# CONTEXT MAP DERRYDOWN WAY SIDEWALK

# BENEFITS OF WATER QUALITY BASIN/PERMEABLE PAVEMENT DERRYDOWN WAY SIDEWALK

NOVEMBER 2023

# DERRYDOWN WAY SIDEWALK ALIGNMENT OPTION A

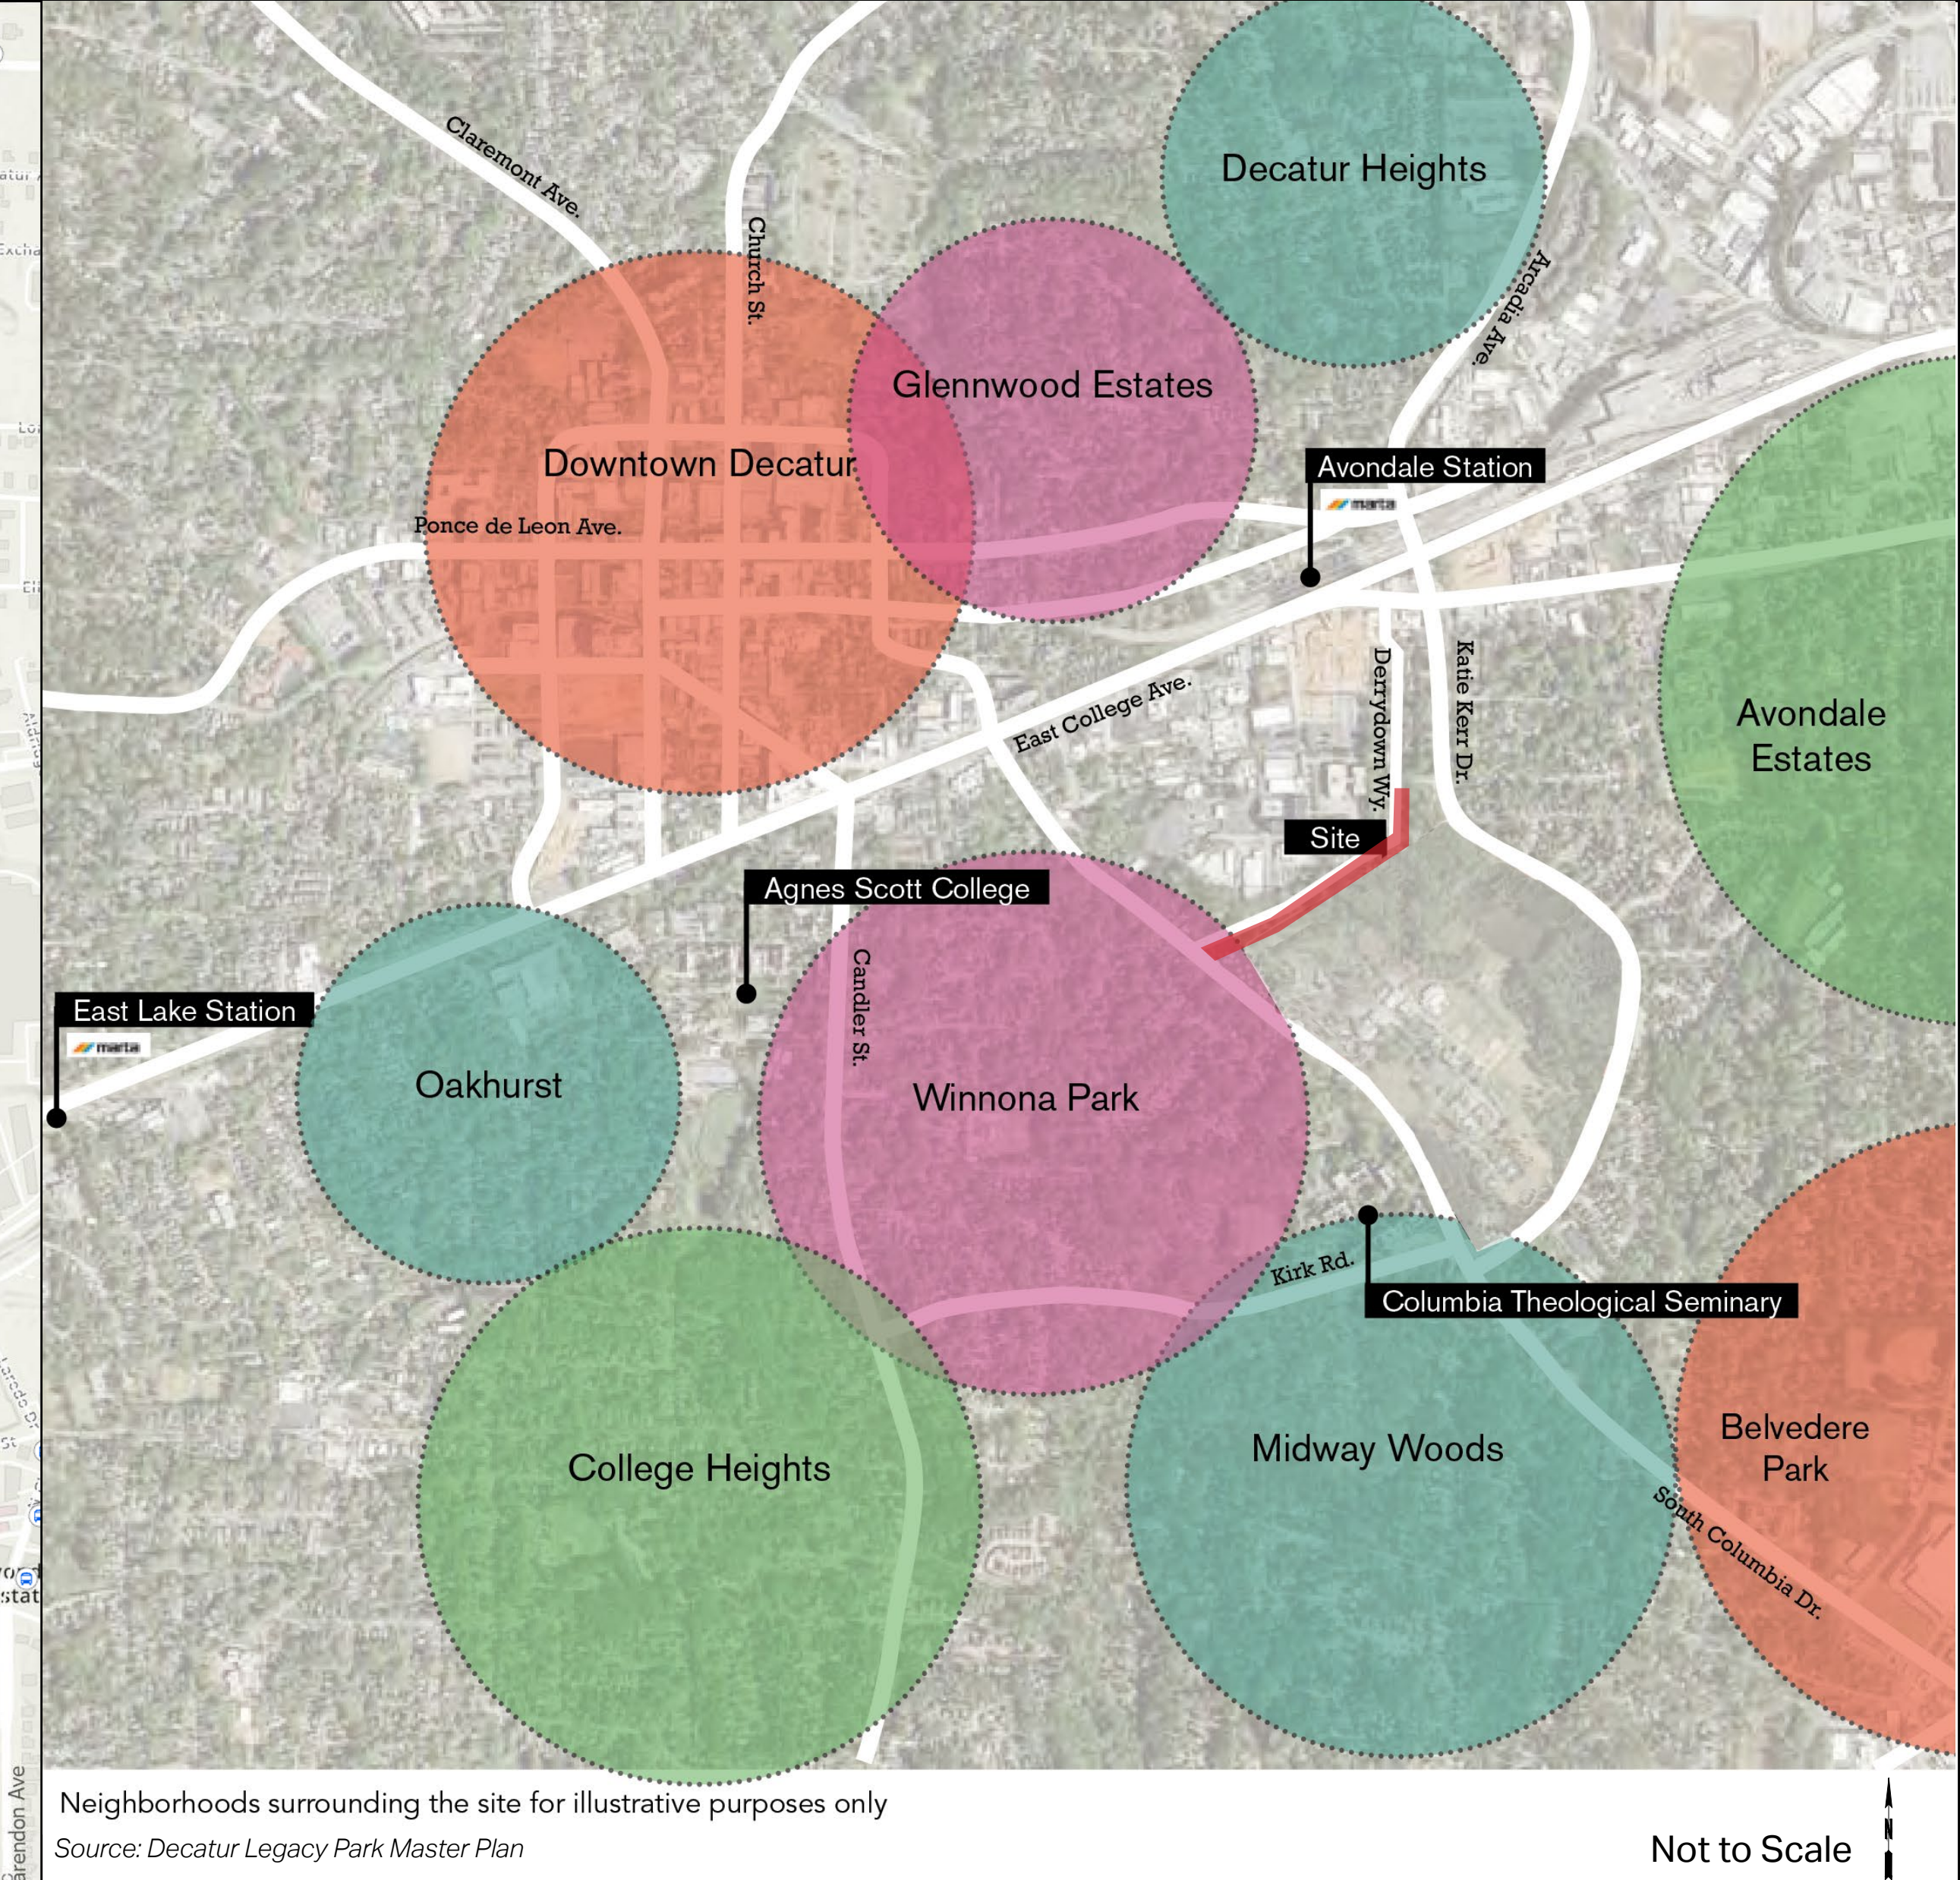
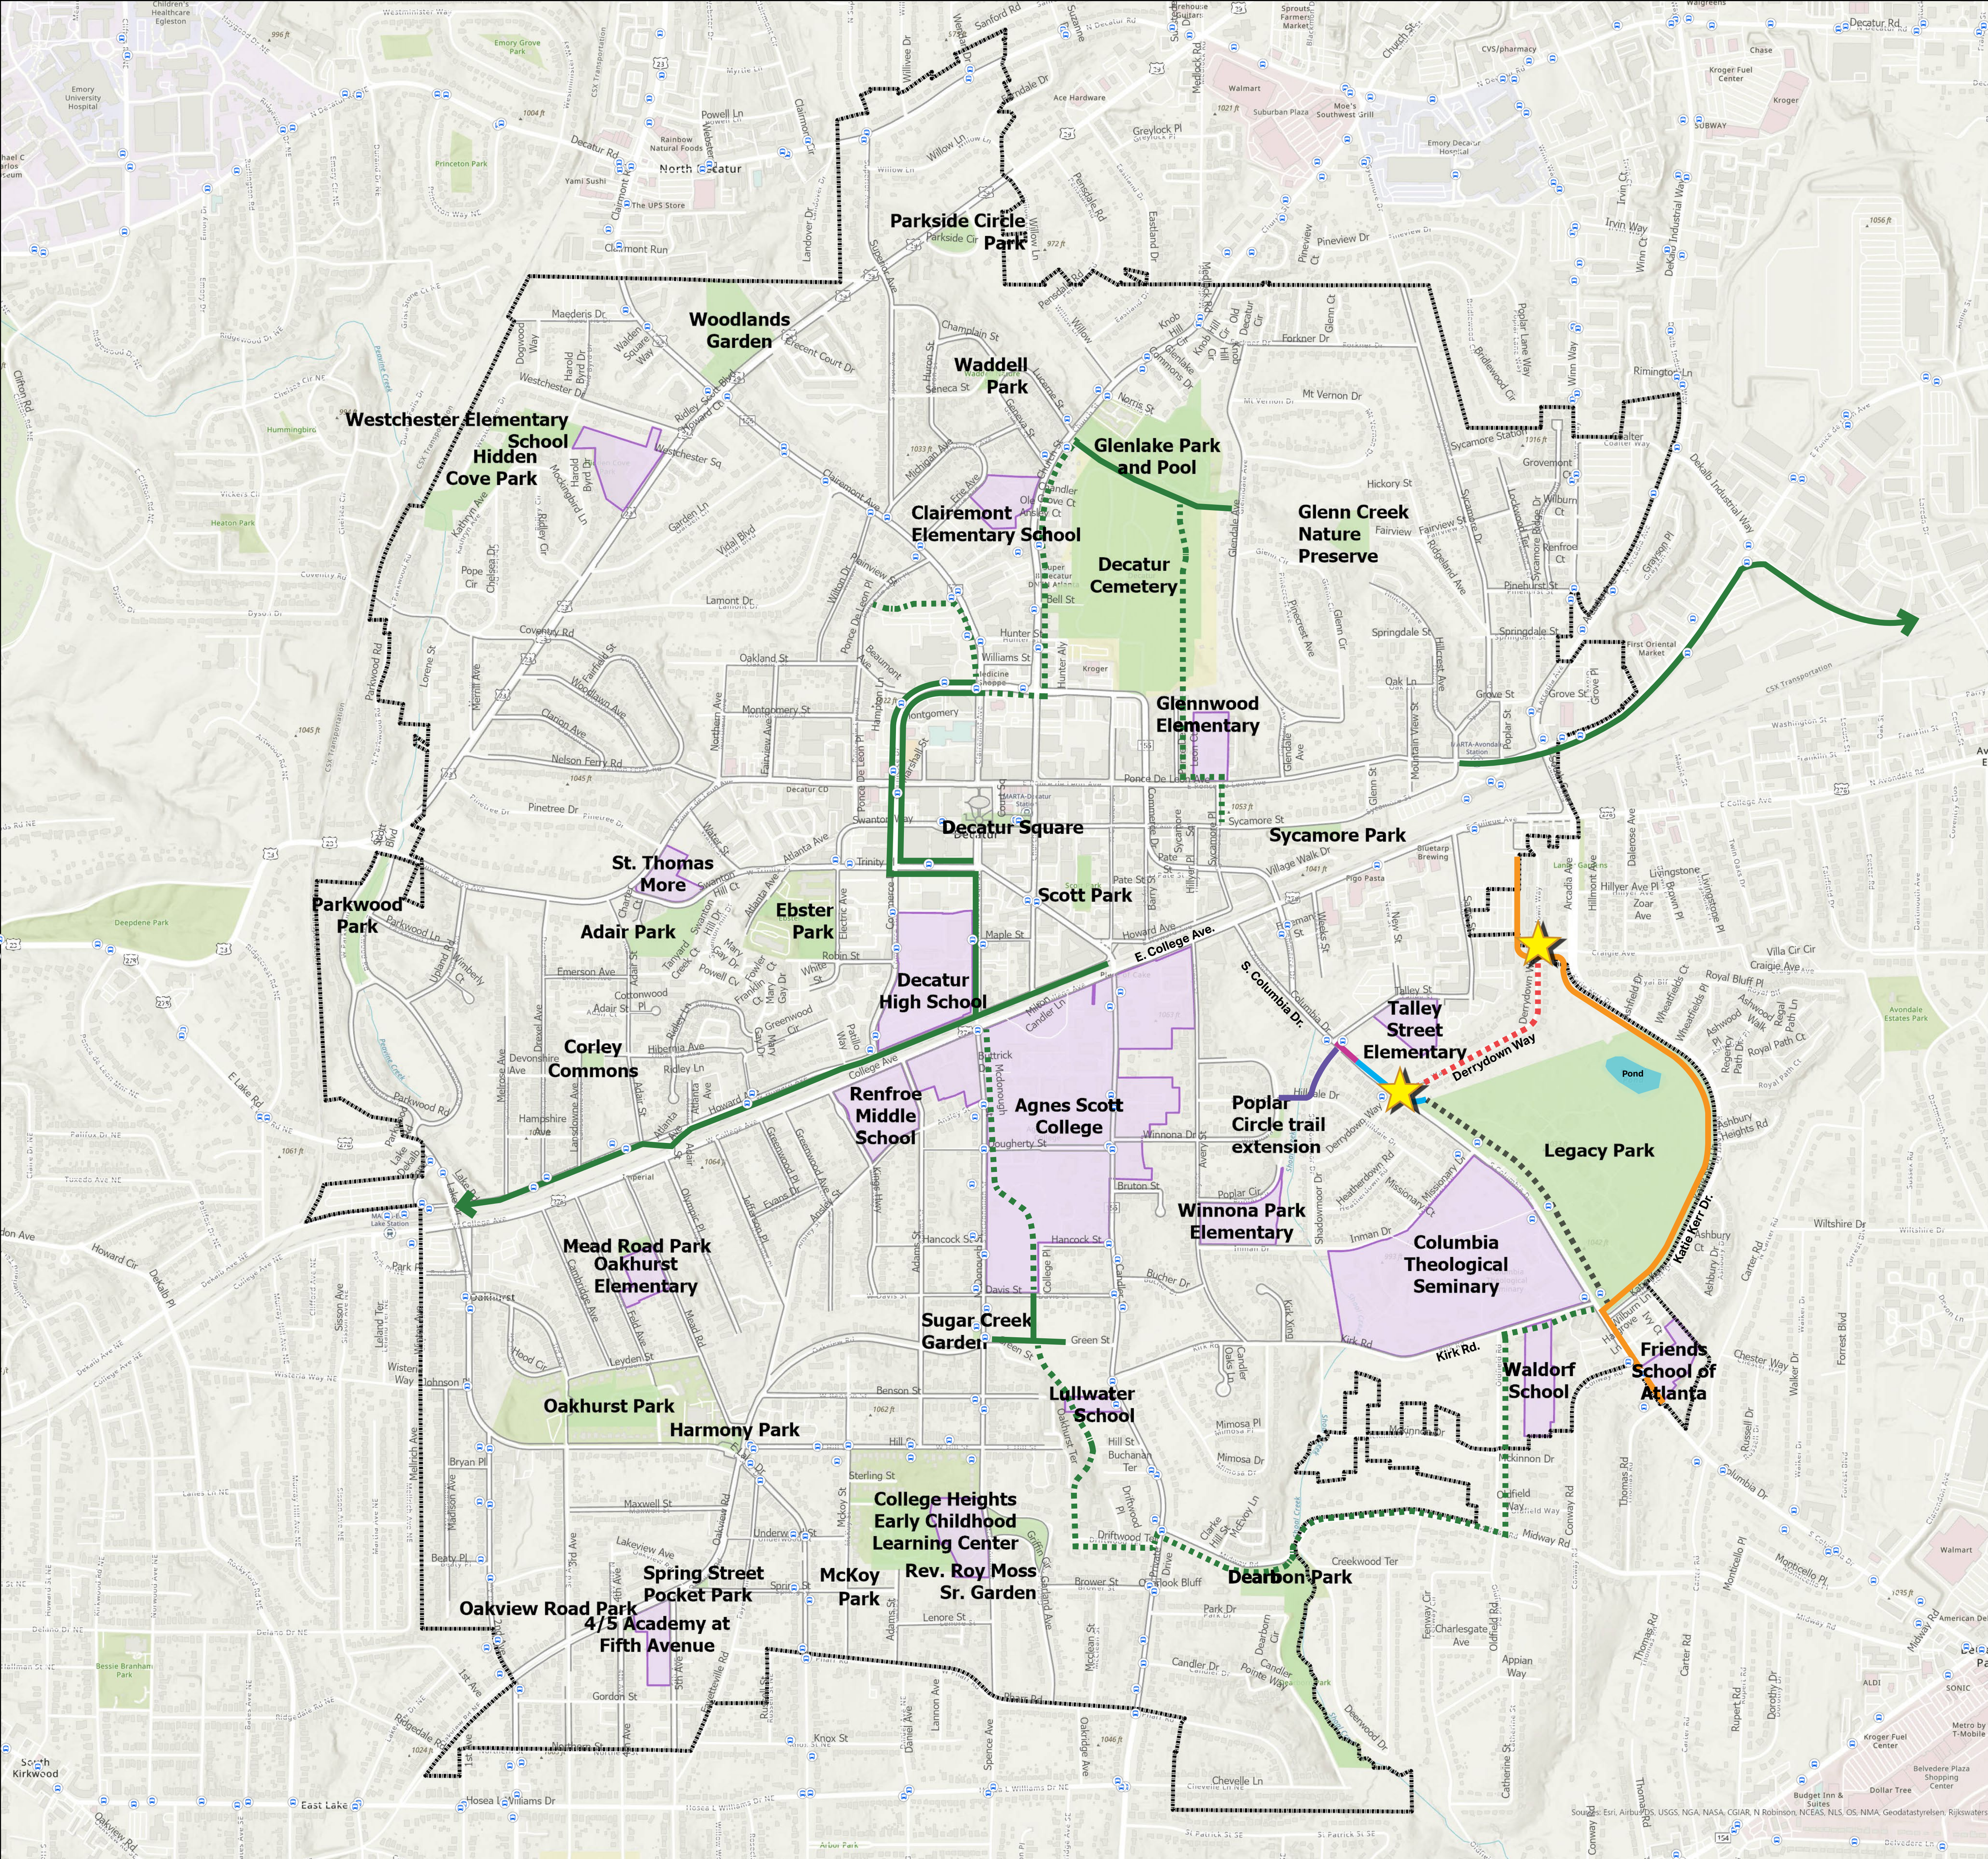
## “Very concerned about the slopes if the sidewalk goes on the West side...”

Our Response: The West side does have a steeper topography increasing the design complexity. This would lead to greater property impacts and increased costs to regrade the ground.
